ASSESSMENT REPORT

Section 75W Modification

Mayfield West Remediation Project (DA 381-12-2001-i MOD 3)

Figure 2: Approved remediation areas under DA 381-12-2001-i, including current staging

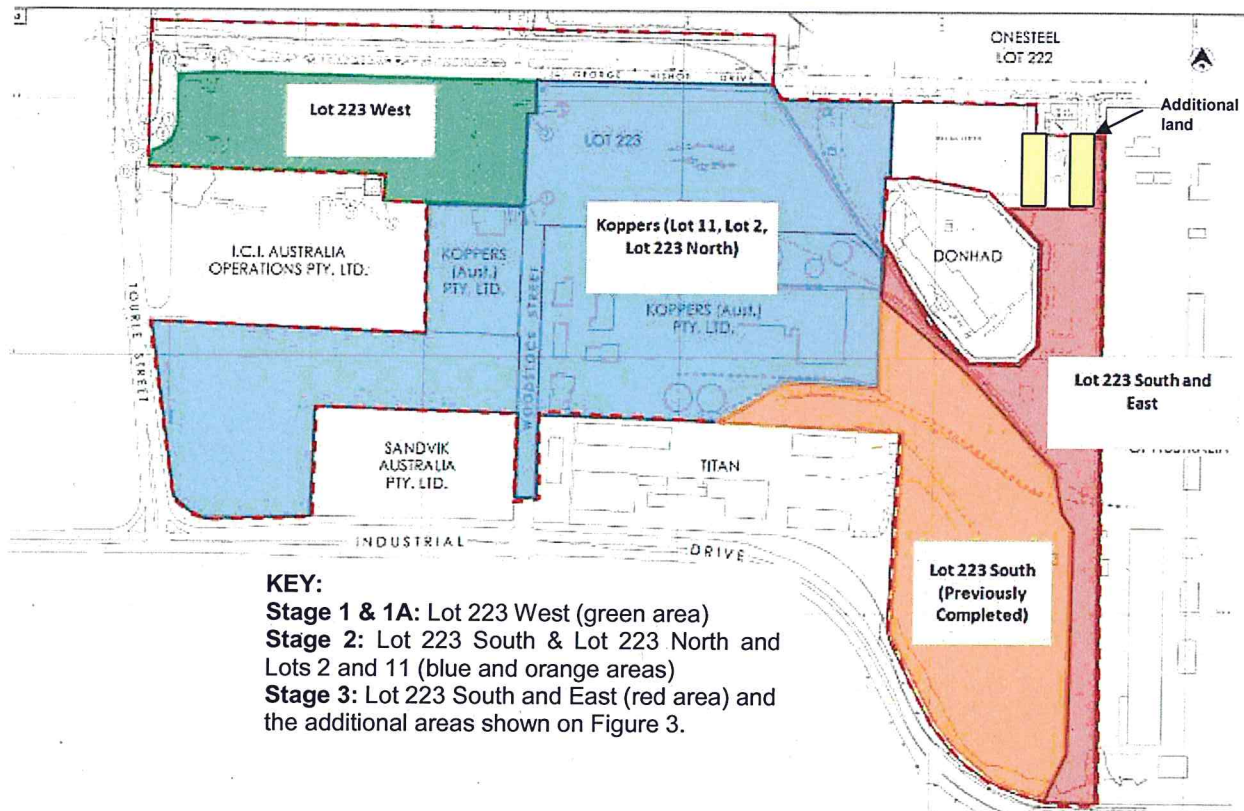
1. Lot 223 West (shown in green shading on Figure 2).

As described above, BHPB has already completed remediation on Lot 223 West (**Stage 1**). CWR was used to cap this area; however in 2006 it was found that the CWR had acid generating potential, triggering the need for further monitoring and remediation. As a result, BHPB is now proposing to remove a thin veneer of the existing CWR cap and install a new cap consisting of road base/asphalt. The revised remediation of this area is to be referred to as **Stage 1A**.

2. Lot 223 South and East (shown in red shading on Figure 2).

BHPB proposes to cap this area with imported clay-based VENM or excavated natural material (ENM), rather than CWR as originally approved. The area would either be revegetated or asphalt sealed following installation of approved drainage. These works are referred to as **Stage 3**.

Figure 3: Additional land to be included in Stage 3 as part of this modification application.

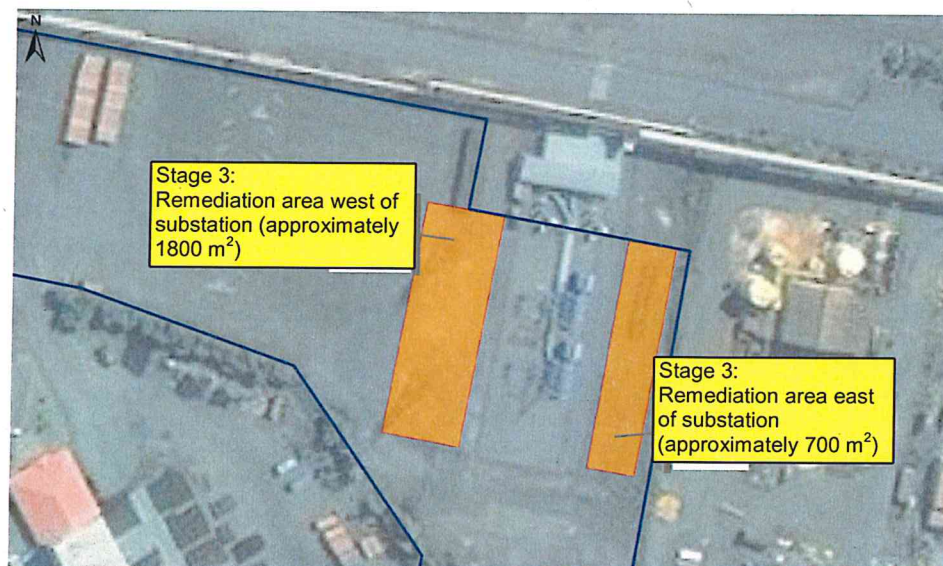
BHPB proposes to remediate two additional parcels of land on the north-eastern portion of Lot 223 (shown in Figures 2 & 3). The land is located on each side of a BHPB managed substation. These two small areas combined are around 2500m² in area and are proposed to be included as part of the Stage 3 works.

A different method of remediation has been proposed in these areas whereby deep excavations are being avoided. This is due to underlying and overhead cables/lines/pipes, and to ensure the integrity of the two nearby transmission towers is maintained. Nevertheless, the proposed spray sealed asphalt finish would still meet the permeability requirements of the cap which as set out in Condition 8 of the consent.
